TPB Ref.: A/YL-KTS/1154

Temporary Logistics Centre with Ancillary Facilities and Associated Filling of Land for a Period of 3 Years at Lot 403 RP (Part) in D.D. 103 and Adjoining Government Land, Kam Tin, Yuen Long, New Territories

Response to DSD's comments - Proposed Temporary Logistics Centre for a Period of 3 Years and Filling of Land in "Agriculture" Zone, Lot 403 RP (Part) in D.D. 103 and Adjoining Government Land, Kam Tin, Yuen Long, New Territories (Application No. A/YL-KTS/993)

Figure 4

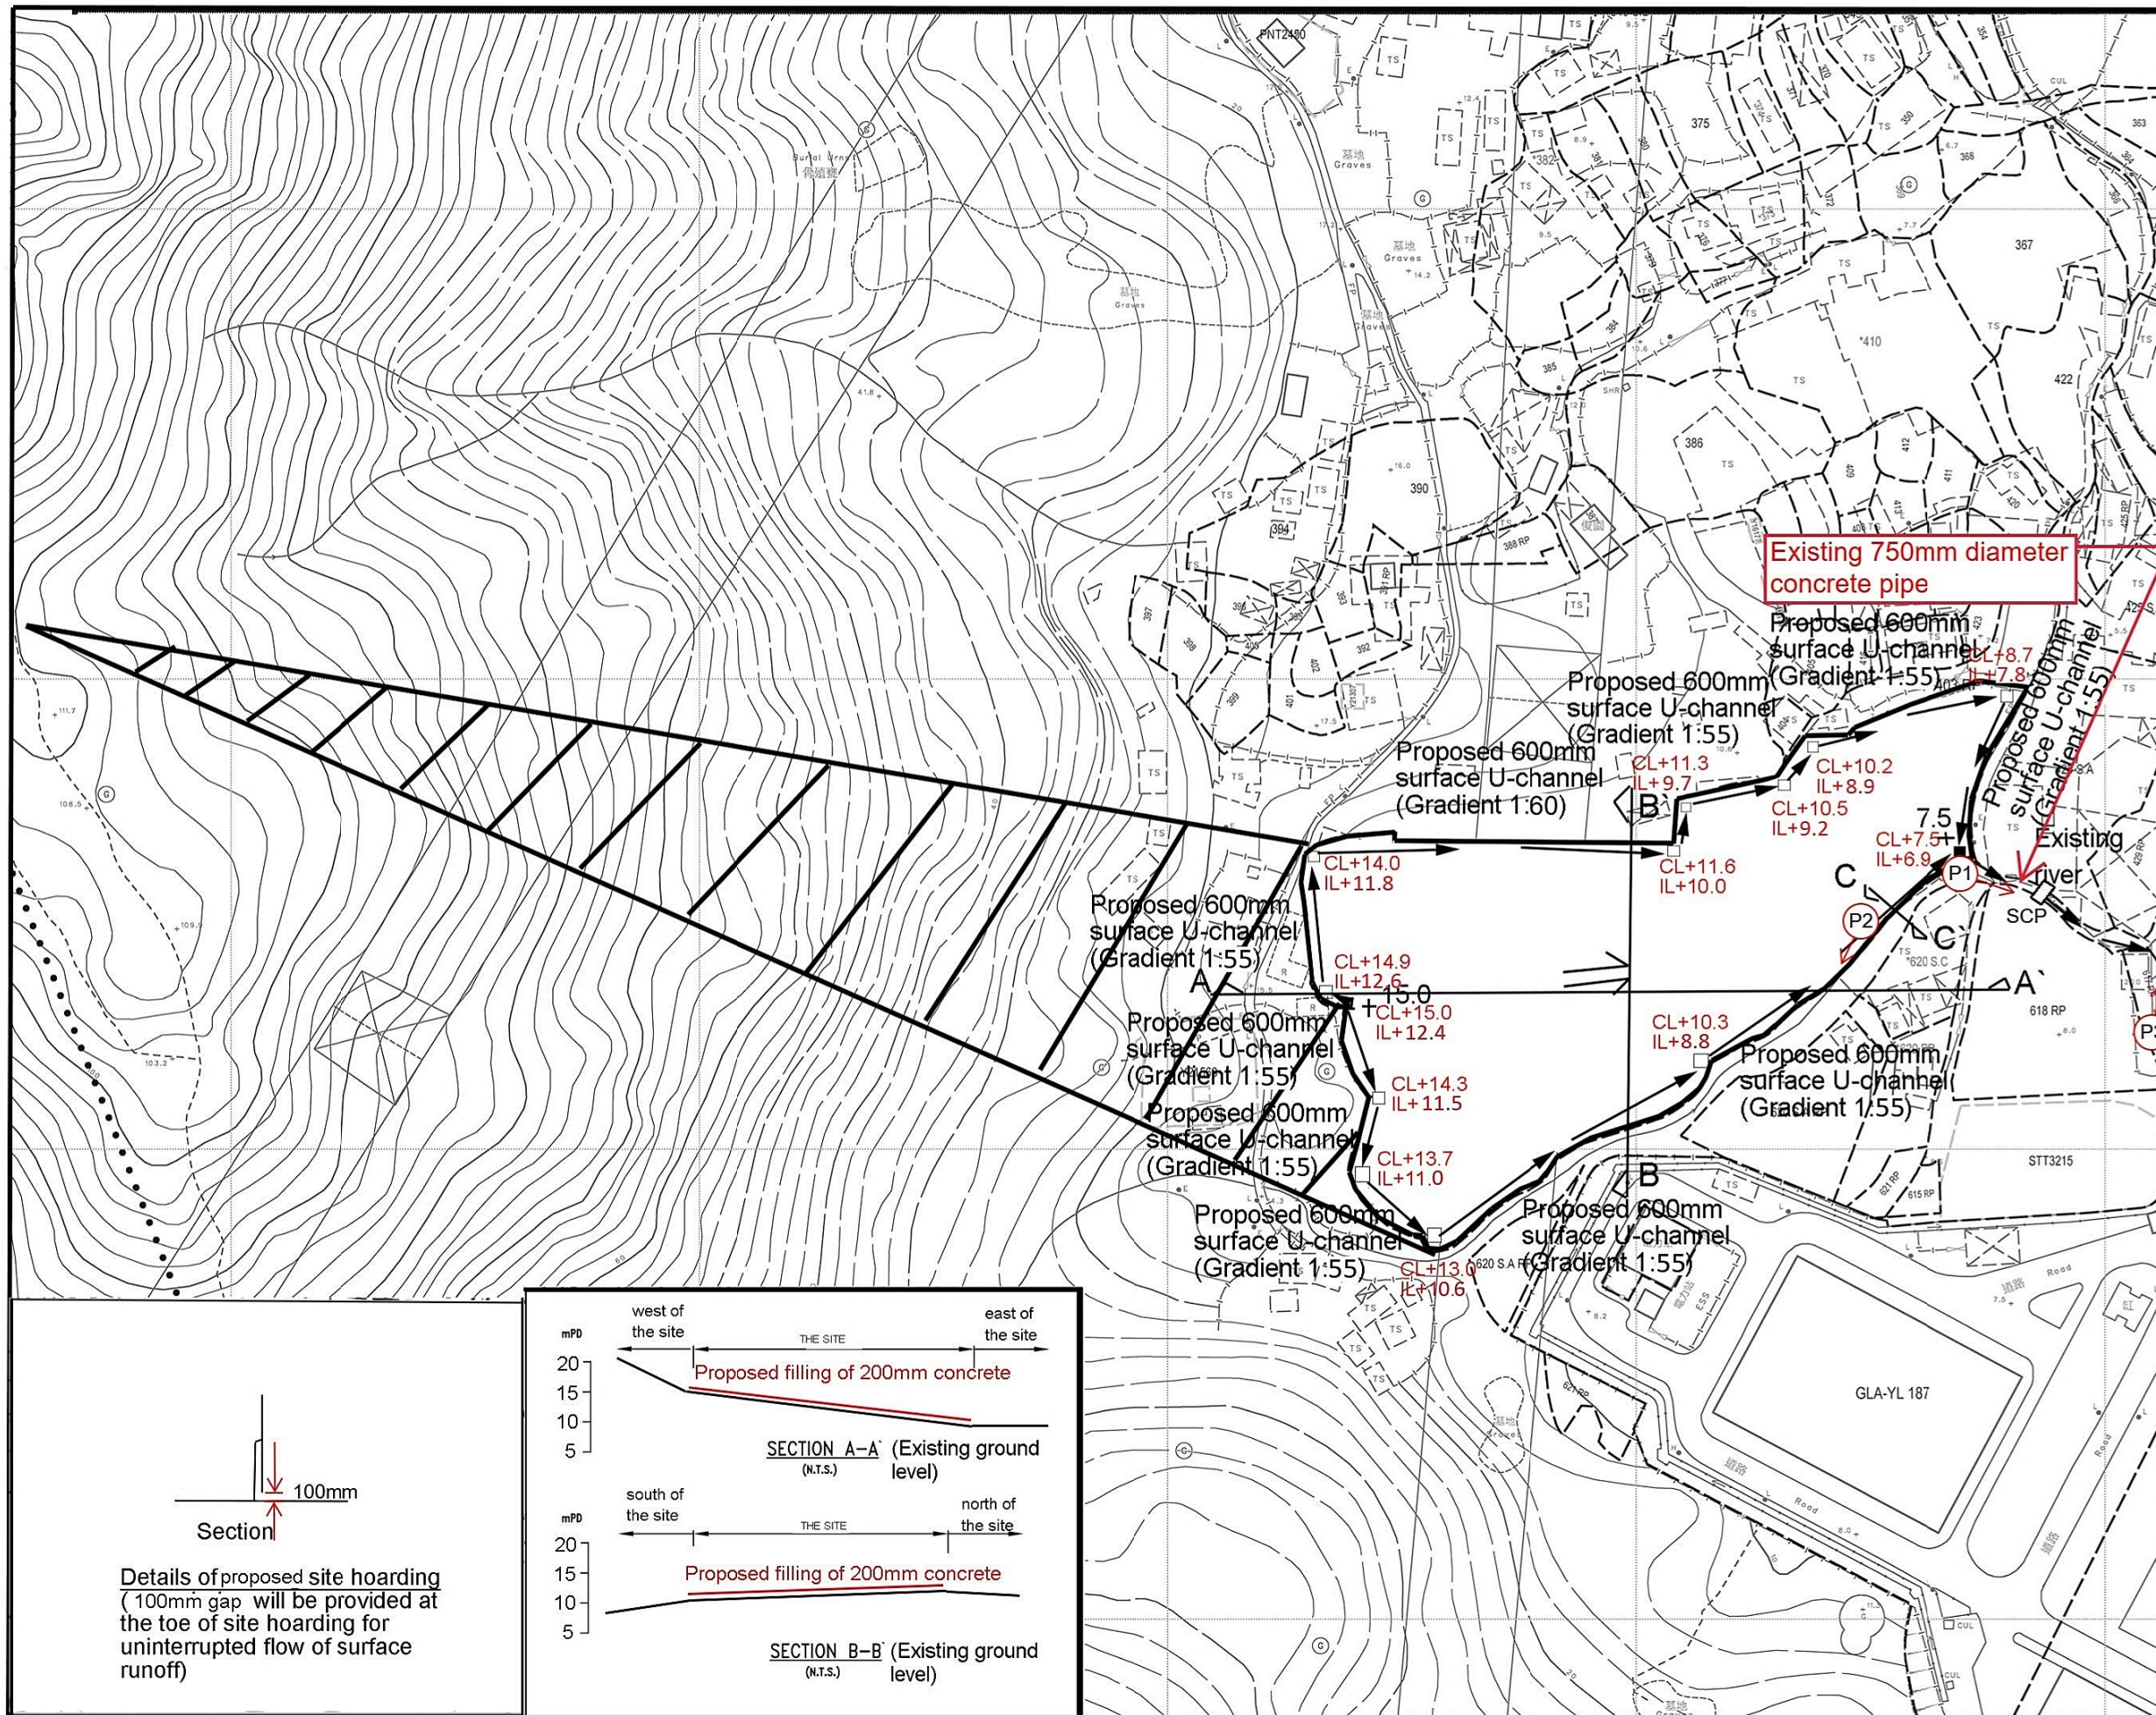
(a) Please indicate the existing opening drain and the discharge path on photo 1 & 2. Please also indicate the photo taken directions on drawing.	please see the updated Figure 4.

(b) Please show the size of the existing drainage facilities, i.e. the aforementioned existing opening drain and the discharge path, on drawings.	please see the updated Figure 4.

(e) The velocities of stormwater flow in channels should be checked and given in the submission.	please see the enclosed design chart which shown the revised gradient is 1 : 55 and the velocities of stormwater flow in channel is around 3.9m/s.
Please specify the distance between the proposed gaps and the height of the 100mm gaps in figure 4.	please see the updated Figure 4.

Figure 5 - Catchpit (SCP)

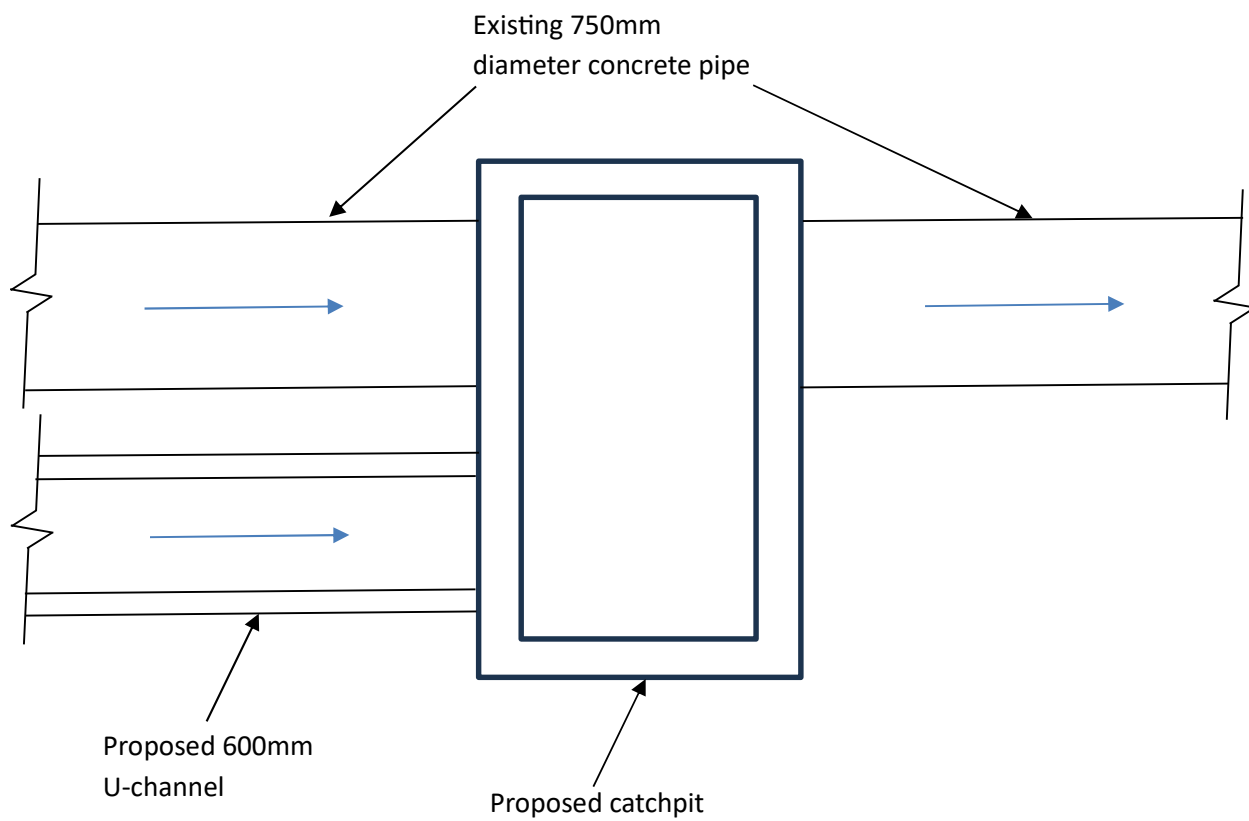
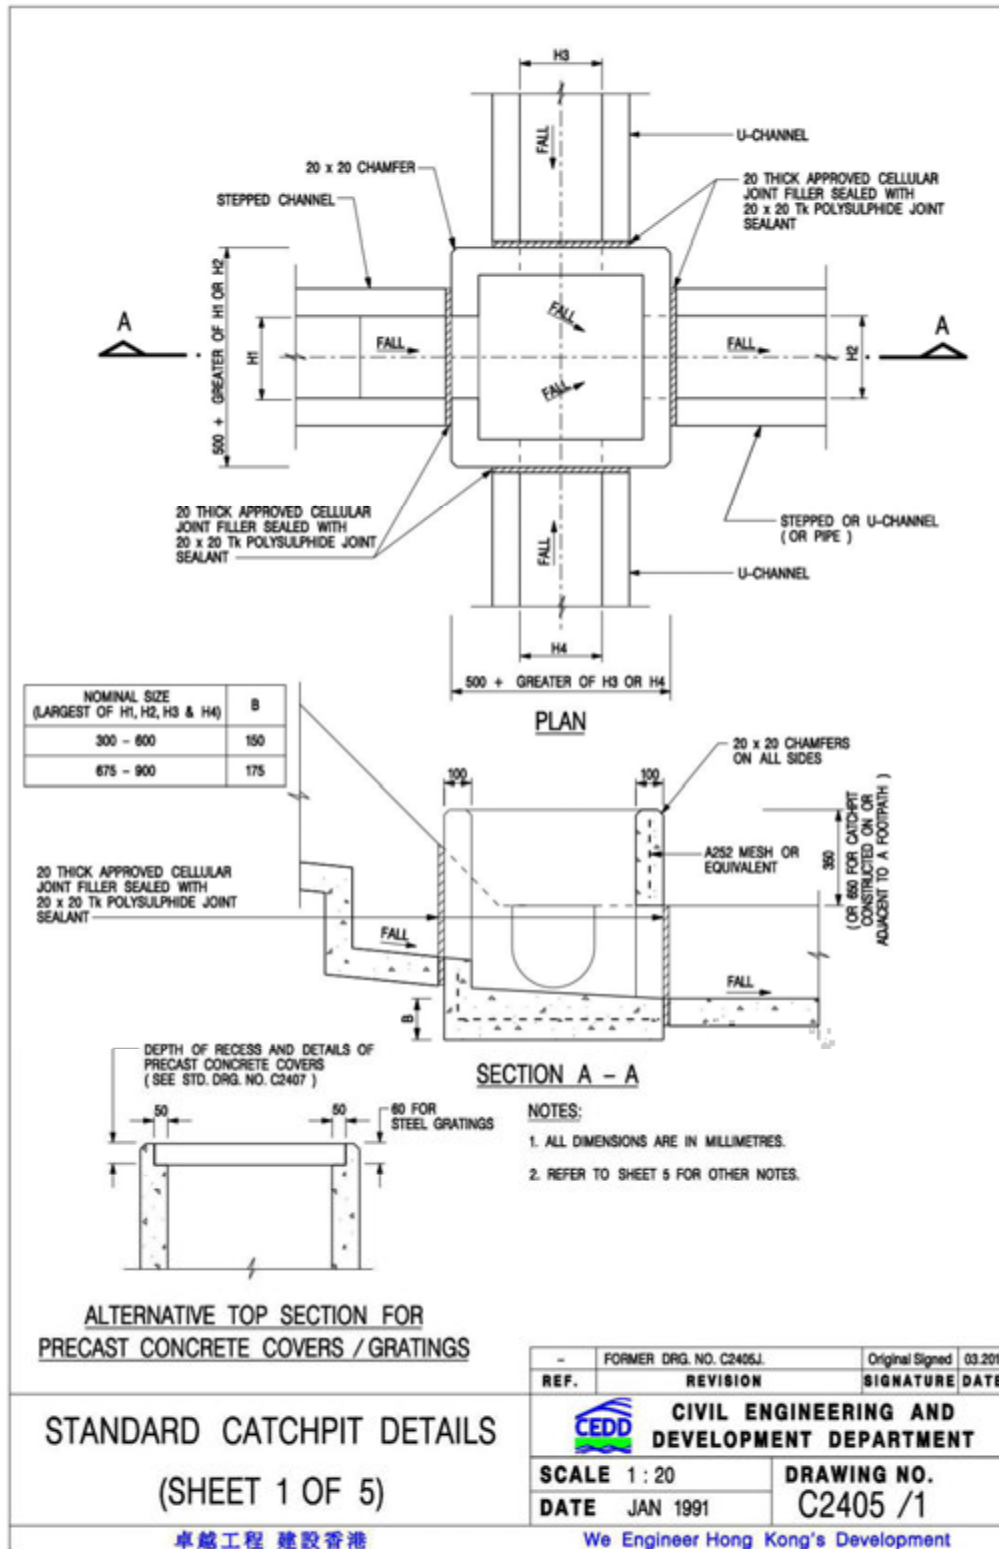
(c) Connection details of the proposed channel at the proposed channel at the proposed discharge point at river should be given.	please see the enclosed Figure 5.

FIGURE 6

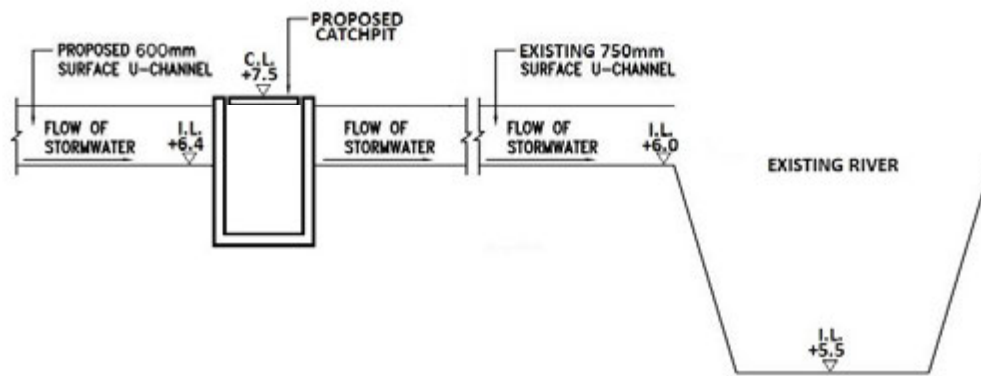
(i) The connection details (figure 6) submitted is not tally with the details showed in figure 5 below. Please clarify. Please also show the C.L., I.L. and G.L. of the existing/proposed pipe/channel and existing river in figure 6.	please see the revised Figure 6.
--	----------------------------------
